## REMARKS

The present application includes pending claims 1-19. By this Amendment, claims 1-3, 7, 13-14, and 19 have been amended. It is respectfully submitted that the pending claims define allowable subject matter.

# REPLACEMENT SHEET

## FIG. 2

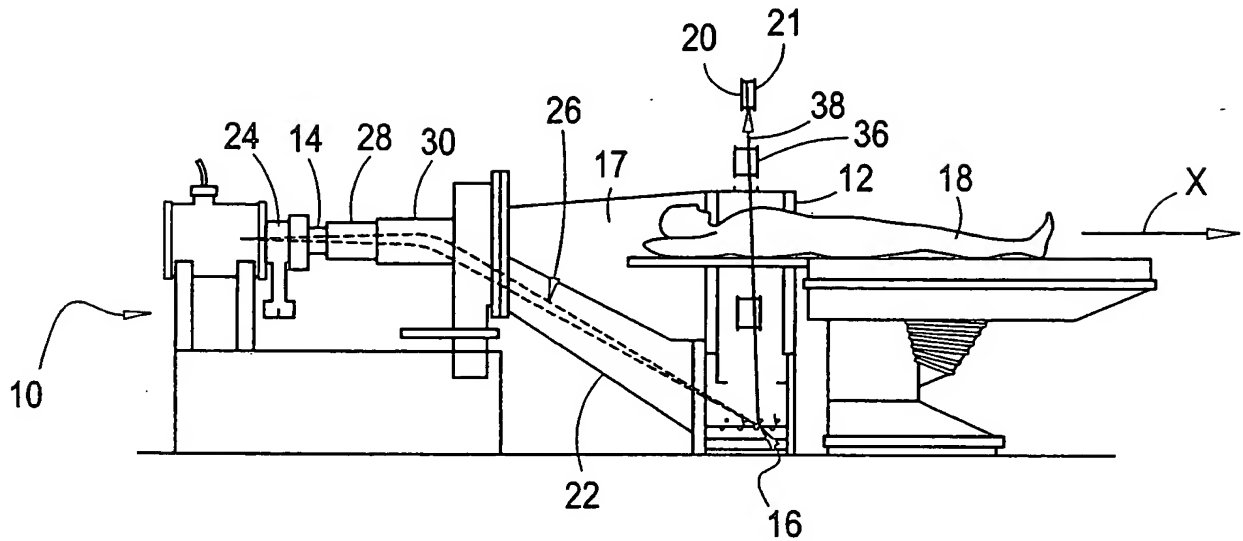
The drawings were objected to because reference character "18" was used to designate two different objects in Figures 1 and 2. The Applicant has attached a "Replacement Sheet" of amended drawings. The drawings have been amended to show that reference numeral 18 in Figure 2 refers to the patient, just as in Figure 1.

The drawings were also objected to because Figure 2 includes "OR" and "SOR." The Applicants submit that "OR" refers to "Overlap Region," while "SOR" refers to "Source Only Region." Nevertheless, the Applicant has amended Figure 2 to delete "OR" and "SOR" to avoid any confusion.
